# UNITED STATES PATENT AND TRADEMARK OFFICE

APPLICATION NO.	FILING DATE	FIRST NAMED INVENTOR	ATTORNEY DOCKET NO.	CONFIRMATION NO.
10/502,416	07/23/2004	Daniel Greub	0115-044591	3939
28289 7590 12/11/2008 THE WEBB LAW FIRM, P.C. 700 KOPPERS BUILDING 436 SEVENTH AVENUE PITTSBURGH, PA 15219			EXAMINER CHIEM, DINH D	
			ART UNIT 2883	PAPER NUMBER
			MAIL DATE 12/11/2008	DELIVERY MODE PAPER

<b>Office Action Summary</b>	<b>Application No.</b> 10/502,416	<b>Applicant(s)</b> GREUB, DANIEL	
	<b>Examiner</b> ERIN D. CHIEM	<b>Art Unit</b> 2883

### **DETAILED ACTION**

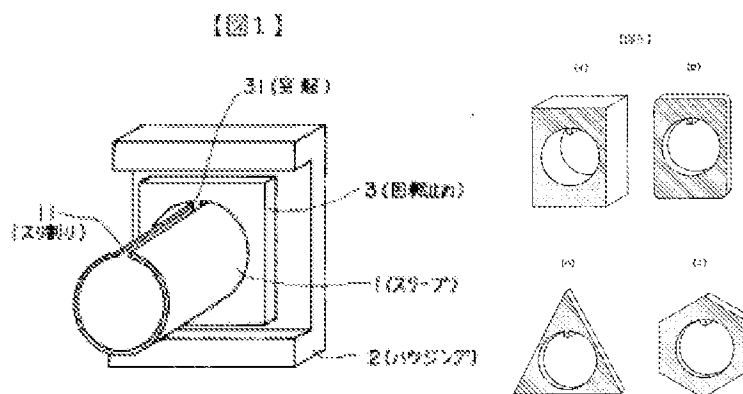
- A securing plate retained in a rotationally secure manner directly between the flanges and engaging the longitudinal slit of the sleeve by way of protuberance
- The securing plate and the depressions each have a peripheral contour (e.g., square)
- The protuberance engages in the slit without projecting into an interior of the sleeve.
- The sleeve mount comprises means for defining the angle of rotation (e.g., bevels) orientation provided on the securing plate and the mount parts.

Ishikawa discloses all of the elements in which Kakii does not teach in the following drawing.

It would have been obvious at the time the invention was made to a person having ordinary skill in the art to provide means alone or in combination for securing the sleeve from rotating. **The motivation** for providing securing plate is to further secure the split sleeve without having an extra split sleeve as shown by Kakii in Fig. 3 to hold the securing element (2) within the split (11). The plate, as shown by Ishikawa is produced with the protuberance and will remain flushed against the flange once the connector counter part is fitted together. Therefore, the means of preventing rotational play disclosed by Ishikawa is an improvement over the disclosure

by Kakii since the protuberance is manufacture in the fashion which does not require an additional assembly step.
